## **PARTS BULLETIN No. 1-17**

### **Subject: NEW PART - UNF BLADE ADAPTOR BOLT SET P/N 05258**

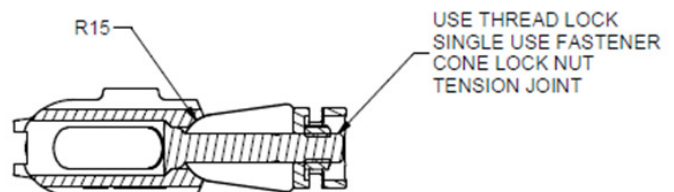
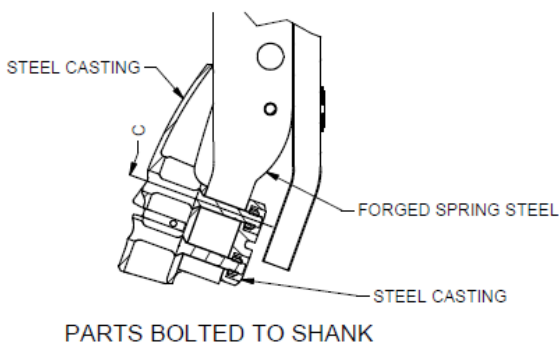
For increased user serviceability, all future Pro-D blade adaptor kits will be supplied with a new 1/2" **UNF** socket bolt, and 1/2" **UNF** conelock nut.

The new bolt allows for an 8mm (5/16) Allen key for additional support when tightening and loosening the blade adaptor nut.

As this new bolt is not a direct replacement from the previous 1/2" **UNC** blade adaptor bolt, customers will need to purchase;

**05258 Bolt Set 1/2" x 3 1/8" UNF to Suit Blade Adaptor \$3.75 RRP Excl. GST**

Apply Loctite and tighten to 100-110 lb-Ft (135-148 Nm).
